VILLAGE OF ESTERO
ZONING
STAFF REPORT

CASE TYPE: ADMINISTRATIVE AMENDMENT
CASE NUMBER: ADD2015-E003
CASE NAME: COCONUT RETAIL CENTER
PLANNING & ZONING BOARD DATE: DECEMBER 15, 2015

REQUEST AND STAFF RECOMMENDATION

SHEET NUMBER: C-5

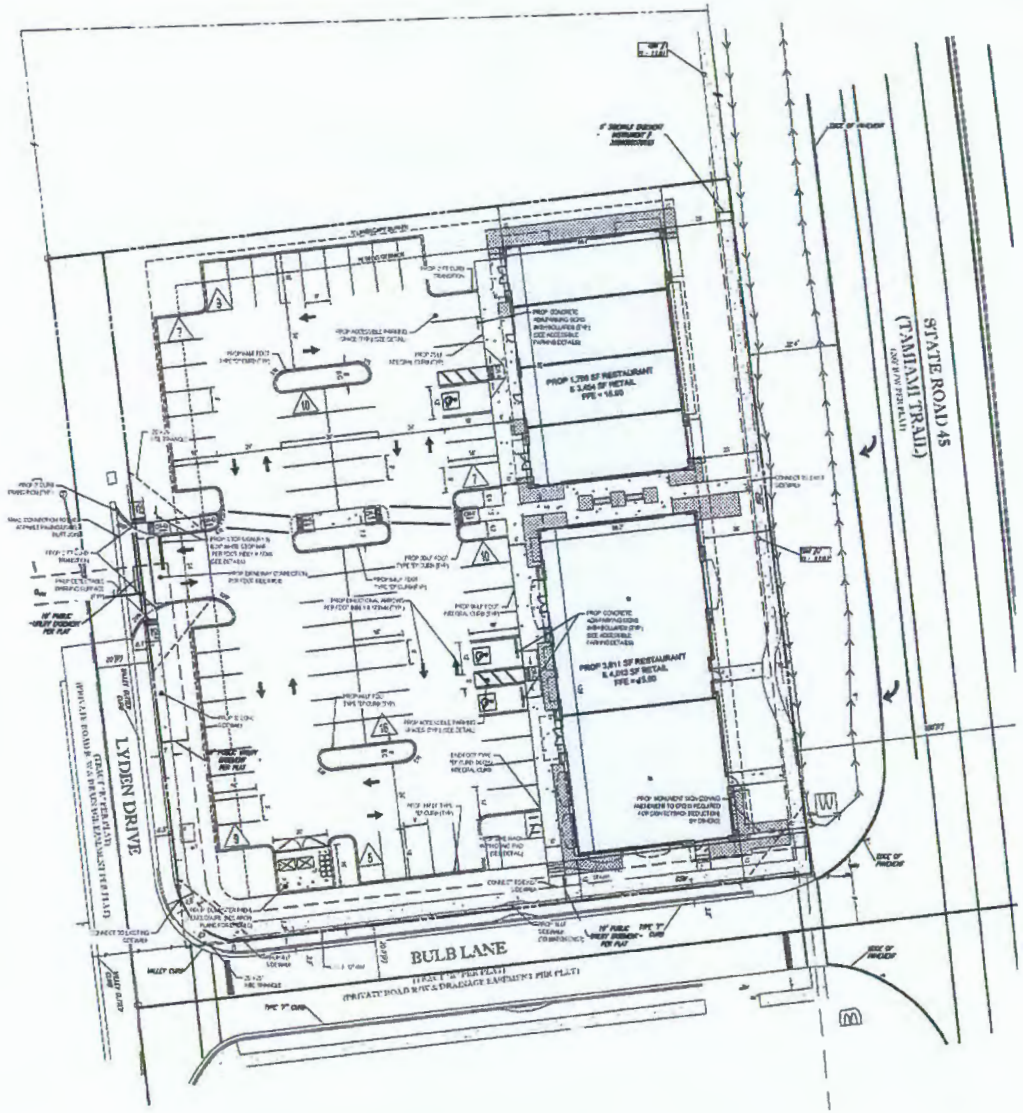
The applicant is proposing a retail use on the 1.34 acre site. The following deviations are requested and include the reduction of the monument sign setback located on the southbound and westerly side of US 41, reduction of the parking requirement by 10% and reduction of the parking stall depth.

The applicant requested a deviation from LDC Section 33-385 (a) (3). This section requires a monument sign setback of 15 feet whereas the applicant has requested a 10 foot setback. The applicant had indicated that the minutes from previous Design Review Board (DRB) public meetings expressed preference for monument signs to be located close to the property line to ensure visibility from landscaping features. The DRB expressed no objection to this request.

Staff believes the proposed setback of ten feet (10') rather than 15 feet required by the LDC will not impact surrounding properties, pedestrian access or vehicular traffic. The monument sign complies with all other aspects for the requirements of LDC sections 30 and 33 as approved by the DRB. Staff does not object to granting of the deviation.

LDC Section 34-2020 allows a maximum reduction of 10% for parking spaces, when an applicant complies with one or more of the conditions listed in LDC Section 34-2020 (c) (1 through 7). A total of 81 parking spaces are required and the applicant provides 73 parking spaces. The proposed plan shows pedestrian and bicycle access and proper access is provided for all pedestrian/bicycle traffic from US 41 and satisfies the condition listed per LDC Section 34-2020 (c) (3). Bike lanes adjacent to the subject site are depicted on Comprehensive Plan Map 3D-2 which satisfies the condition listed per LDC Section 34-2020 (c) (3). A transit stop is also located within 500 feet of the site and in front of the Autumn Leaves Memory Care Facility. Staff believes the applicant has met three of the requirements listed per LDC Section 34-2020 (c) (3) and does not object to the granting of the deviation.

The applicant requested a deviation from Section 34-2016 (1) (b) of the LDC. This section of the LDC requires a 90 degree parking stall depth of 18 feet whereas the applicant proposes 16 feet. The DRB requested the applicant to provide additional landscape planters between the parking area and buildings. As per the DRB's request, the applicant proposes to preserve the existing western buffer landscaping and shade trees. In order to comply with the DRB's request, the applicant proposes to reduce the parking stall depth to 16 feet along the western perimeter of the parking area. A total of 16 parking spaces will be impacted by this request. Staff believes a parking stall depth reduction from 18 feet to 16 feet will not impair vehicles from safely entering and exiting the parking area and does not object to the granting of the deviation.

2. The deviation for the monument sign setback of 10 feet is approved, provided the site layout is in substantial compliance with the attached Site Plan and Site Layout Plan Sheet No. C-5 stamped by the Engineer on 11/23/2015 marked as Exhibit B.

3. The deviation for a maximum parking space reduction of 10% is approved, provided the site layout is in substantial compliance with the attached Site Plan and Site Layout Plan Sheet No. C-5 stamped by the Engineer on 11/23/2015 marked as Exhibit B.

4. The deviation for a parking stall reduction for 16 parking spaces is approved, provided the site layout is in substantial compliance with the attached Site Plan and Site Layout Plan Sheet No. C-5 stamped by the Engineer on 11/23/2015 marked as Exhibit B.
